Access Compliance Report Public Rights-of-Way (Curb Ramps)

Main Street: ANTONIO_PKWY Cross Street: BENJAMIN_DR Location: W

ADA ID: RPRK211028164326 Ramp Type: Type 1 - Perpendicular Diagonal Initial Pass/Fail: Fail Overall Compliance: No Severity Score: 30

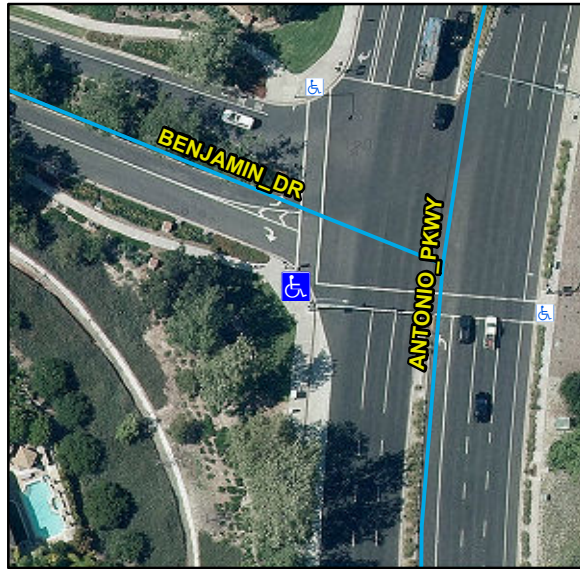
R304.2.2, R204.3, R304.5.3, STD 1115

Compliance	Description	Data	Compliance	Description	Data
N/A	Ramp Length (in)	127	N/A	Flare Type LT	
Yes	Ramp Width (in)	48			N/A
Yes	Ramp Run Slope (%)	4.7	N/A	Flare Slope LT (%)	N/A
No	Ramp Cross Slope (%)	8	N/A	Flare Traversable LT	N/A
N/A	Landing Present	N/A	N/A	Flare Type RT	
N/A	Landing Length (in)	N/A			N/A
N/A	Landing Width (in)	N/A	N/A	Flare Slope RT (%)	N/A
N/A	Landing Run Slope (%)	N/A	N/A	Flare Traversable RT	N/A
N/A	Landing Cross Slope (%)	N/A	N/A	DWS Provided	N/A
N/A	Landing Movement Obstructed?	N/A	N/A	DWS Contrast	N/A
	Landing Movement Type	N/A	N/A	DWS Length (in)	N/A
N/A	Landing Shared	N/A	N/A	DWS Full Width	N/A
N/A	Clear Space	Yes	N/A	DWS Offset Left (in)	N/A
N/A	Clear Space To Crosswalk (in)	48	N/A	DWS Offset Right (in)	N/A
N/A	Marked Crosswalk 1	Yes	N/A	Marked Crosswalk 2	Yes
	Crossing 1 Direction	SE		Crossing 2 Direction	NE
	Marked Crosswalk 1 Width (in)	144		Marked Crosswalk 2 Width (in)	144

Remove & Replace Curb Ramp With Two New Directional Ramps or Equivalent.
